AMENDMENT OF SOLICITATION/MODIFICATION OF CONTRACT	1. CONTRACT ID CODE	PAGE OF PAGES
---	---------------------	---------------

FLUID DRUM & HOSE
 REEL DETAILS

Interior and Exterior Repairs
 to HP 100

PBD2

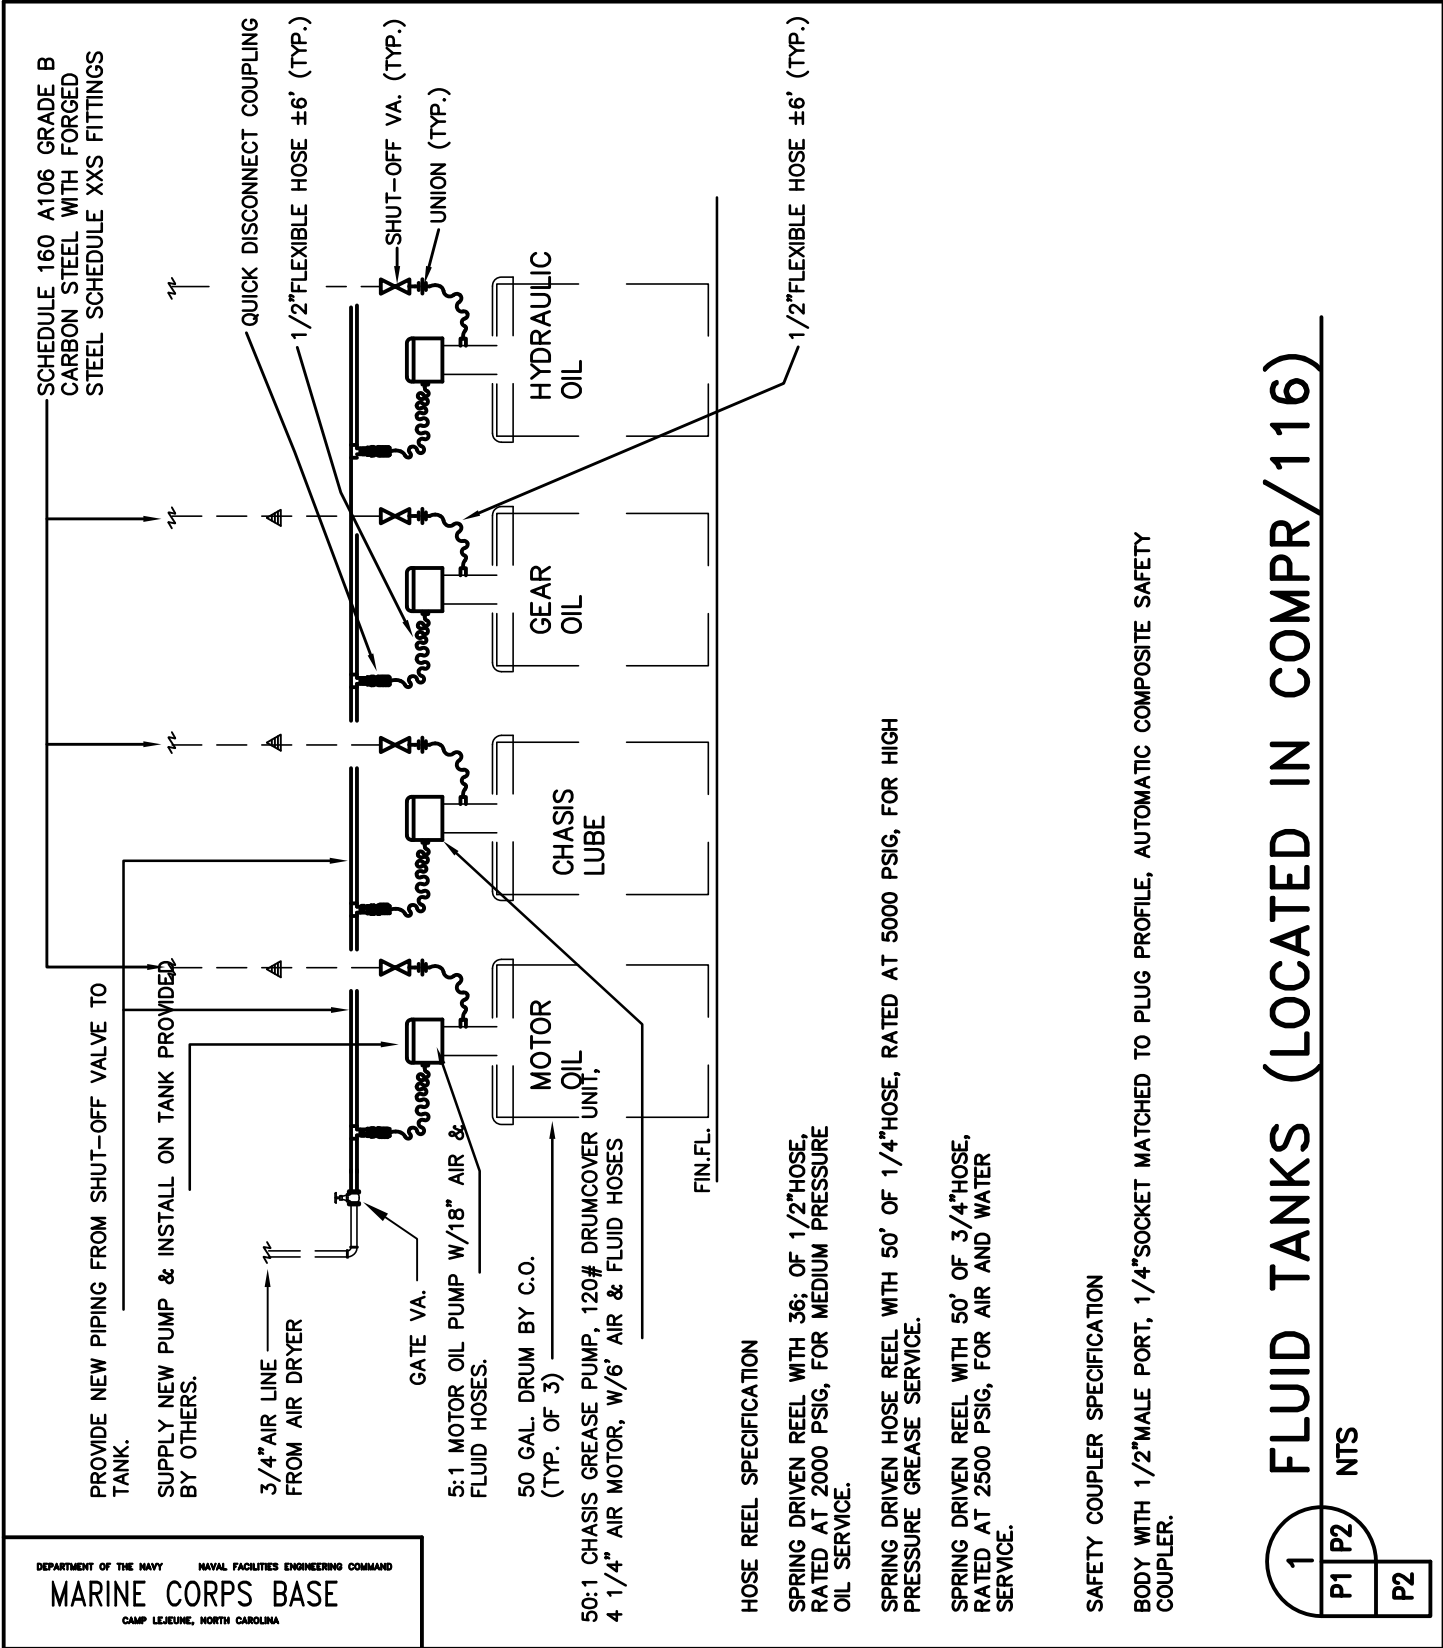
- 3) Question: Sheet P-2 gives us a specification for the hose reels, and appears to give a detail of how piping is attached to oil, grease, and transmission drums. What is the intent for this detail? We are not told to do anything with it, such as "provide new," or "connect to existing." Where it is located on the drawings, etc. Please advise.

Answer: Remove the existing lube pump and modify the piping adjacent to the drums. See bulletin drawings PBD2 and PBD3 for clarification (Pages 4 and 5).

PROVIDE PUMP & PIPING TO CONNECT TO EXISTING DRUMS. REFER TO DETAIL 1/P2 & PBD3

PROVIDE NEW PIPING TO POINT OF CONNECTION TO EXISTING PIPING
